RESPONSES TO COMMENTS
TELECOPIED FROM NRC
TO ENERGY FUELS NUCLEAR
25 September 1978

DAMES & MOORE
4 October 1978

QUESTIONS CONCERNING THE PROPOSED
TAILINGS MANAGEMENT PROGRAM

QUESTIONS CONCERNING THE PROPOSED
WHITE MESA MILL

RECLAMATION SCHEDULE and COSTS³

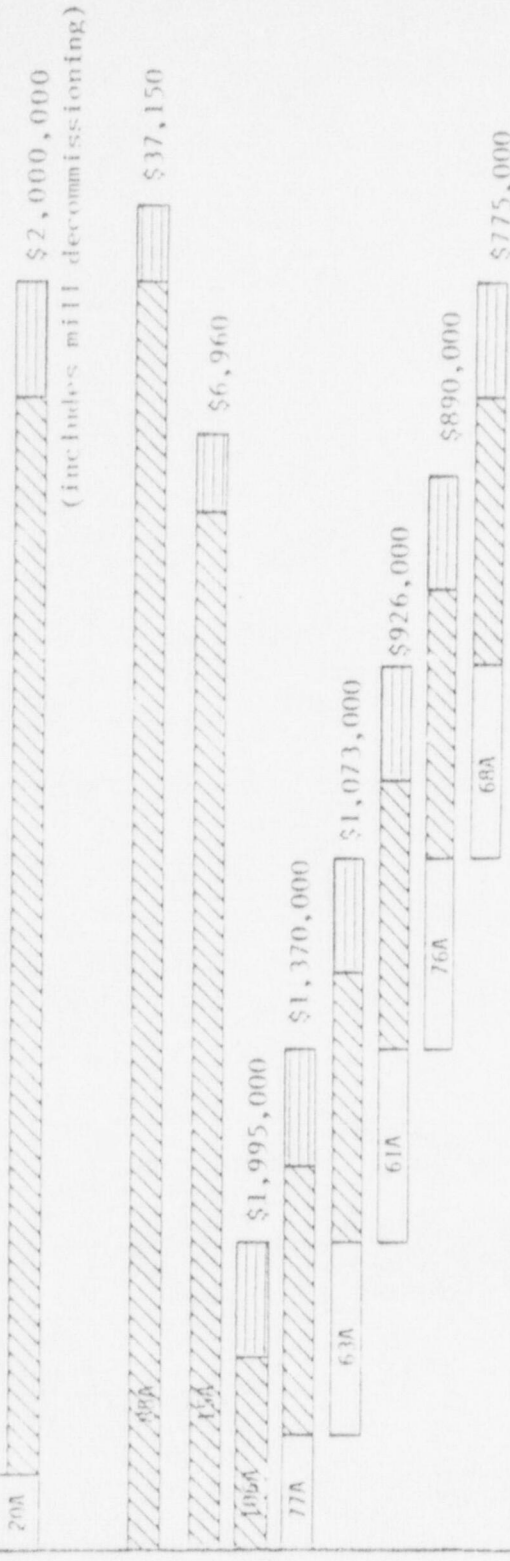
A technical and financial feasibility assessment on methods and overall costs of mill decommissioning and site (including tailings area) reclamation. Note that all future costs should be discounted to present worth.

The reclamation of the tailing area is included in Energy Fuels Nuclear's Source Material License Application, September 26, 1978, Appendix AA, Page 24. In addition, the attached sheet gives the reclamation costs for the individual tailing cells, topsoil, overburden and rock stockpiles and borrow areas. The total cost for the tailing area reclamation in 1978 dollars inflated at 8 percent per year and discounted at 10 percent per year to present worth is \$7,831,110. The tailing reclamation begins after 2.5 years of operation and continues through the entire life of the mill with an average cost per year of \$522,000. The final tailing cell has a total reclamation cost of \$775,000 spread over 1.5 years.

At the end of the 5th year, 2/3 of cell no. 3, and 1/3 of cell no. 4 will require reclamation costing about \$2.3 million. This cost added to the mill and stockpile reclamation costs result in a total decommissioning liability of approximately \$4.3 million.

SOIL SURVEY MAP- PROJECT SITE

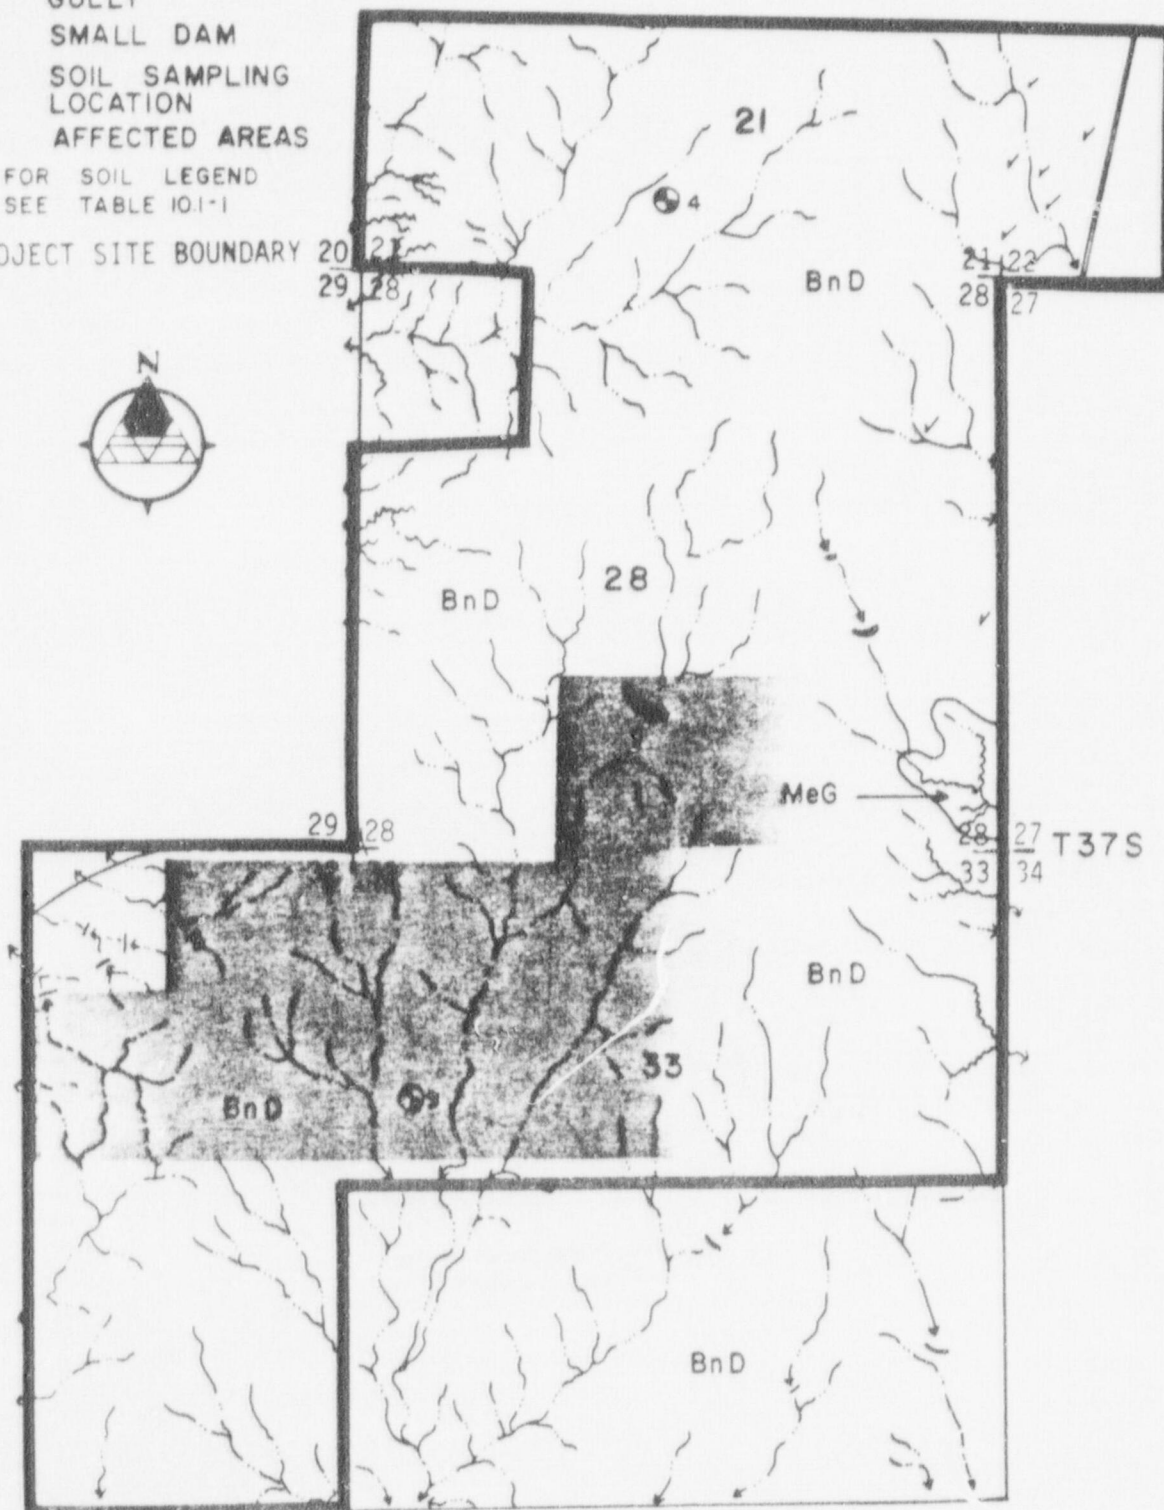
(Section 2.1, Site Location and Layout) "The project site includes all of Section 28 and..." (ER, 2-4, line 6). This statement does not agree with the project boundary map in Plate 2.1-3. Please clarify.
